**CITY OF CEDARBURG
A MEETING OF THE SITE AND ARCHITECTURAL REVIEW BOARD
TUESDAY, FEBRUARY 17, 2026 – 8:30 AM**

PLANNERS REPORT

Request: Recommendation to Plan Commission to approve infill site and house plan as replacement for fire destroyed previous home which was a legal nonconforming structure on a legal nonconforming lot.

Location: N45 W5665 Spring Street

TERRACE REALTY
 PROPOSED SMALL HOUSE
 SPRING STREET
 SHEET 1 OF 4 1/31/26

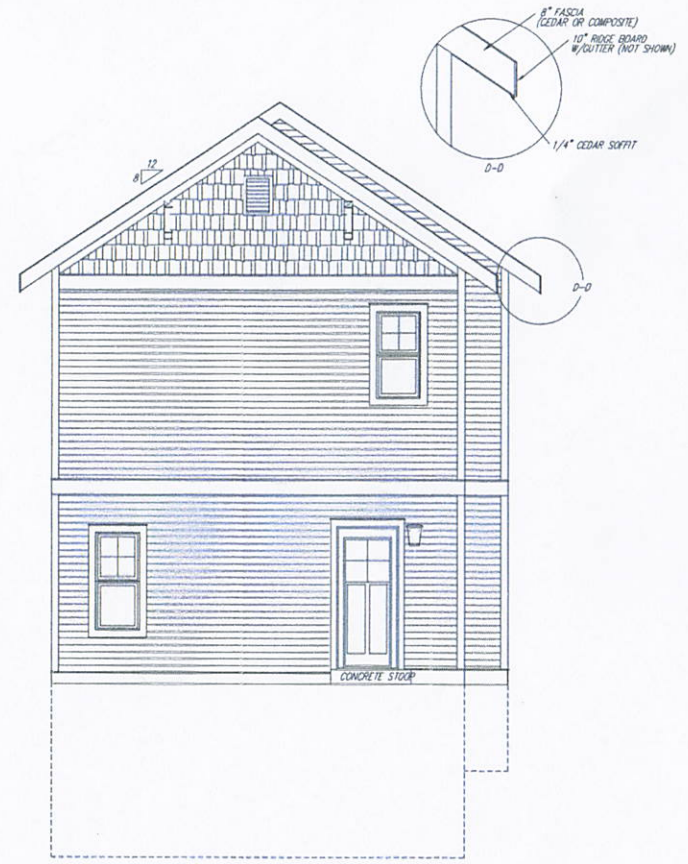
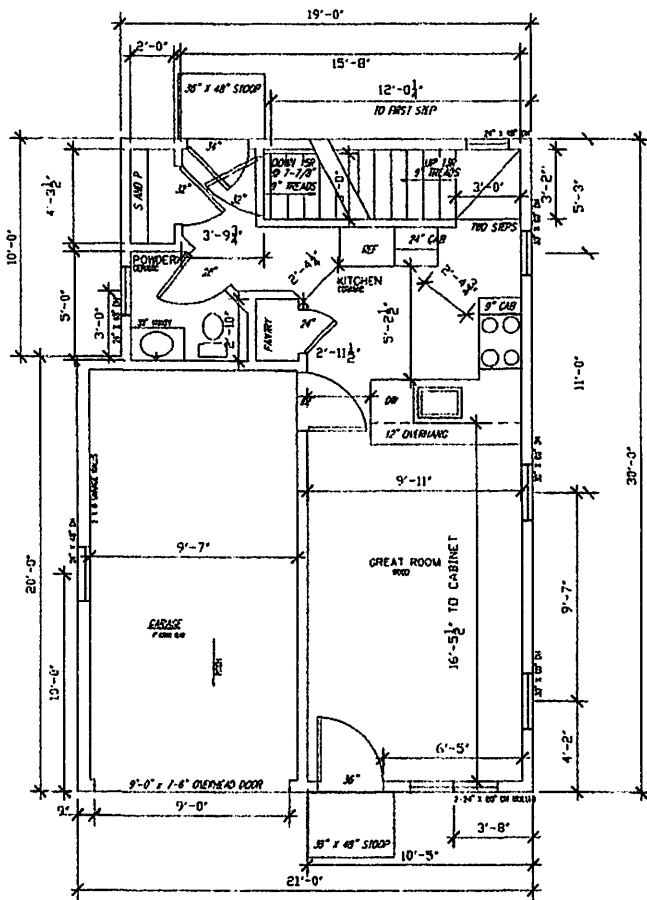
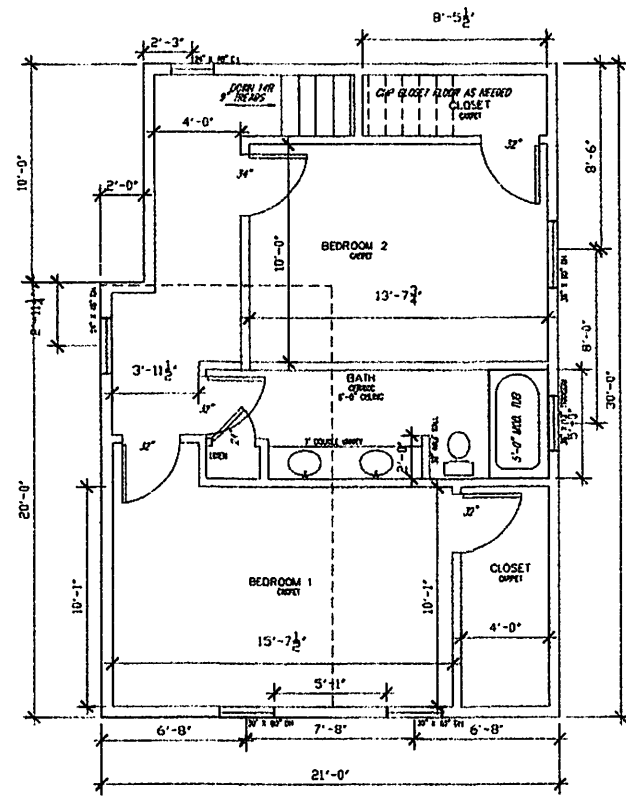
- Minimum req'd lot size 8,400 sq. ft. Actual lot size is ~.15-acres/6,534 sq. ft.
- Minimum req'd lot width 50 ft. Actual lot width is 30.19 ft.
- Maximum permitted building height 35 ft. Proposed building height is <35'

- Minimum req'd principal bldg. floor area 1,100 sq. ft. Proposed p.b.f.a. is 1,040 sq. ft.
- Previously existing p.b.f.a. 1,680 Proposed p.b.f.a. is 1,040 sq. ft.

- Minimum req'd 1st floor area 750 sq. ft. Proposed 1st floor area is 610 sq. ft.
- Previously existing 1st floor area 1,020 sq. ft. Proposed 1st floor area is 610 sq. ft.

- Previously existing lot coverage ratio 26%
- Minimum Req'd front yard setback 25 ft. Proposed is 20 ft.
- Previously existing front yard setback ~3-5 ft. Proposed is 20 ft.

- Minimum req'd sideyard setback 4 ft. Proposed is 3 ft. on west/0' on east
- Previously existing sideyard setbacks ? Proposed is 3 ft. on west/0' on east

This lot is an existing substandard lot. Furthermore, it is not at least 50 wide or 7,200 square feet in area.

- 1) Prior to issuance of Building Permit, applicant shall produce a current plat of survey to confirm that the house, as depicted by its floor plan, indeed fits onto the lot at a 20 foot setback, 3' west side setback, and 0' east side setback.
- 2) Plan Commission (with assistance if/as needed from City Attorney) shall determine that the applicant is indeed eligible to build this home as a replacement to the fire damaged, previously existing, legal nonconforming home/structure on this site.
- 3) Applicant to secure a variance from Board of Appeals as to the proposed <3-foot sideyard offset for driveway if it cannot be reconfigured to comply.
